**Economic Commission for Europe****Inland Transport Committee****World Forum for Harmonization of Vehicle Regulations****Working Party on Automated/Autonomous and Connected Vehicles\*****First session**

**Advanced Emergency Braking Systems****Proposal for a new series of amendments to UN Regulation  
No. 131 (Advanced Emergency Braking Systems)****Submitted by the expert from Germany\*\***

### "Annex 2

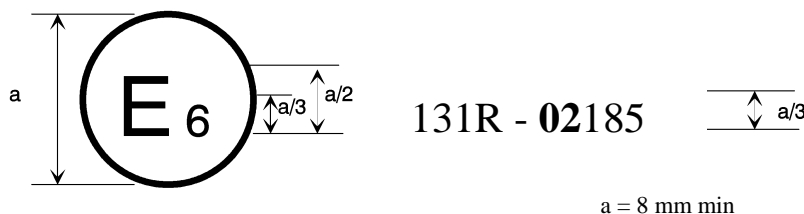
The above approval mark affixed to a vehicle shows that the vehicle type concerned has been approved in Belgium (E 6) pursuant to Regulation No. 131. The first two digits of the approval number indicate that the approval was granted in accordance with the requirements of the **02** series of amendments to the Regulation No. 131"
